<b>Subject:</b>  WHINING NOISE FROM AUTOMATIC TRANSAXLE	<b>Bulletin No:</b> 05-008/16
	<b>Last Issued:</b> 12/07/2016

2012-13 Mazda3 (SKYACTIV A/T)

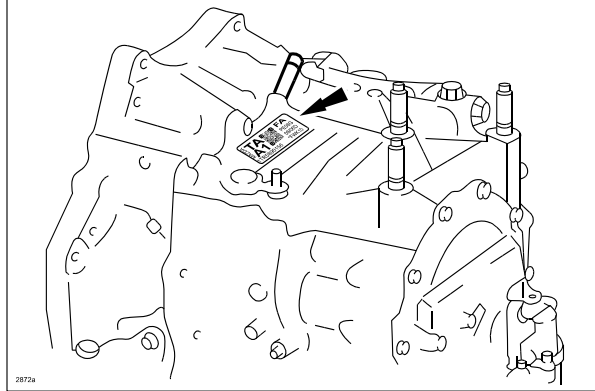
This is caused by a damaged bearing in the transaxle due to improper configuration of the transaxle case. A modification has now been implemented on automatic transaxles with the serial number 3TR1111680 and higher or 3TD1104906 and higher. The serial number can be found on top of the transaxle case near the manual shaft lever.
